W3F1-2018-0030

SUBJECT: Supplemental Information Supporting the Request for NRC Alternative to ASME IWA-5211 Regarding Charging Pipe Visual Inspection, Relief Request W3-ISI-030
Waterford Steam Electric Station, Unit 3 (Waterford 3)
Docket No. 50-382
License No. NPF-38

Supplement to Relief Request W3-ISI-030

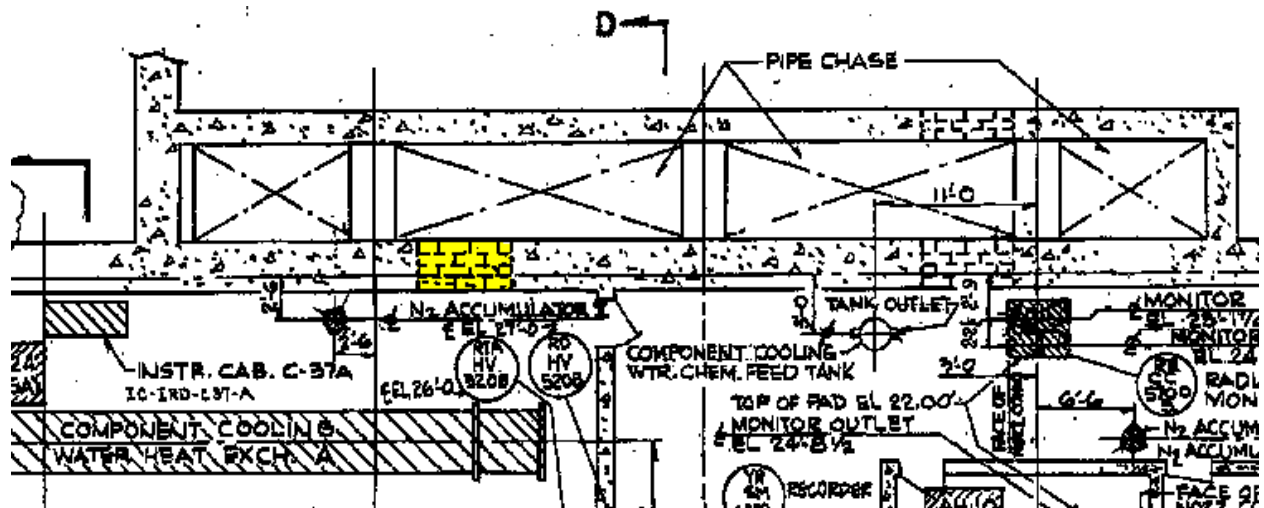
Provide clarification as to whether temporary access through block-out sections is provided during the proposed VT-2 visual examination.

The block-out sections that are utilized during the visual test are provided in Waterford 3 drawing G135, GENERAL ARRANGEMENT REACTOR AUXILIARY BUILDING PLAN EL.+21 FEET. Reference the highlighted section of the portion of Waterford 3 drawing G135 which is provided below. The block-out sections will be of sufficient size to allow entry by plant personnel. Per Waterford 3 American Society of Mechanical Engineers (ASME) Section XI Pressure Testing Procedure, access to the vertical pipe chase is obtained via removal of the L-Wall in Component Cooling Water (CCW) Heat Exchanger 'A; Room and requires a Health Physics Survey and a confined space permit for entry. Additionally, work order instructions direct the removal of the sections of the block wall that will provide access to the vertical pipe chase and the opening must allow personnel entry and installation of scaffolding.
